# UNITED STATES PATENT AND TRADEMARK OFFICE

APPLICATION NO.	FILING DATE	FIRST NAMED INVENTOR	ATTORNEY DOCKET NO.	CONFIRMATION NO.
10/577,996	05/03/2006	Patrick Hermans	016782-0359	4949
22428 7590 11/24/2009 FOLEY AND LARDNER LLP SUITE 500 3000 K STREET NW WASHINGTON, DC 20007				
EXAMINER				
LEE, BENJAMIN P				
ART UNIT		PAPER NUMBER		
3641				
MAIL DATE		DELIVERY MODE		
11/24/2009		PAPER

### Office Action Summary

Andersen

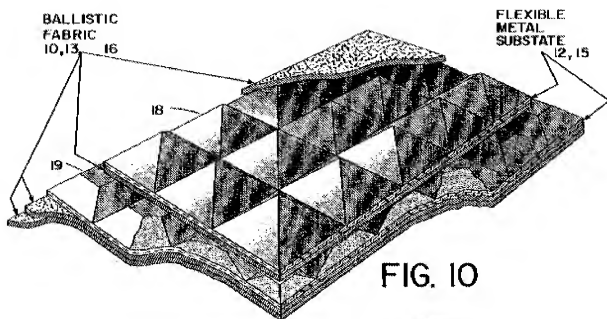
9. In regards to claim 6, Wynne as modified by Andersen discloses that at least one metal layer is multi-directional (see Andersen figures 1 and 2 following). Note that the metal layer construction, when modified by Andersen, teaches a wire mesh layer with "multiple directions".
